Access Compliance Report

Public Rights-of-Way

(Curb Ramps)

Intersection ID: 9087	Main Street: WESTERWOOD_DR	Cross Street: WESTERWOOD_VILLAGE_DR	Location: S
ADA ID: C71FFD51444C	Ramp Type: BlendTrans2	Initial Pass/Fail: Fail	Overall Compliance: No
		Severity Score: 25

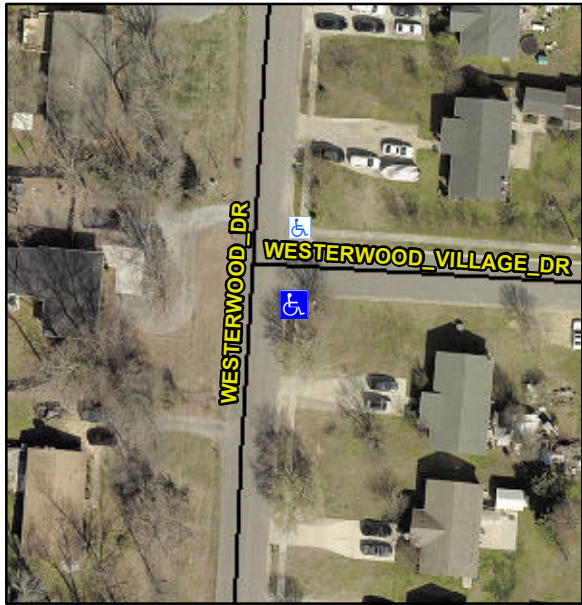
Surveyor Notes:	N/A		N/A	Landing Curb? (Y/N)	N/A	N/A	DWS Offset (in)	N/A
			N/A	Shared Landing?	N/A			
PROW/ADA:			N/A	Gutter Ponding?	N/A	N/A	Gutter Slope (%)	N/A
	R304.5.3		N/A	Gutter Lip Ht (in)	0.5	N/A	Gutter X Slope (%)	N/A
			N/A	Painted X Walk1?	No	N/A	Painted X Walk2?	N/A
				X Walk 1 Direction	To N		X Walk 2 Direction	N/A
				X Walk 1 Width (in)	N/A		X Walk 2 Width (in)	N/A
				X Walk 1 Slope (%)	0.5		X Walk 2 Slope (%)	N/A
				X Walk 1 X Slope (%)	10.1		X Walk 2 X Slope (%)	N/A
			N/A	Ramp inside XWalk1?	N/A	N/A	Ramp inside XWalk2?	N/A
				Road Slope (%)	10.1		Clear Space?	N/A
				Road X Slope (%)	0.5	N/A	Clear Space to XWalk (in)	N/A
			N/A	Any Obstructions?	N/A	N/A	Storm Grate/Utility Hazard?	N/A
				Obstruction Type			Storm Grate/Utility Type	
Total Cost:		\$ 3200.00			N/A			N/A
						Yes	Surface Condition? (G/P)	Good
  						N/A	Curb Slope (%)	1.5

R304.5.3

Remove & Replace Curb Ramp With Two New Directional Ramps or Equivalent.
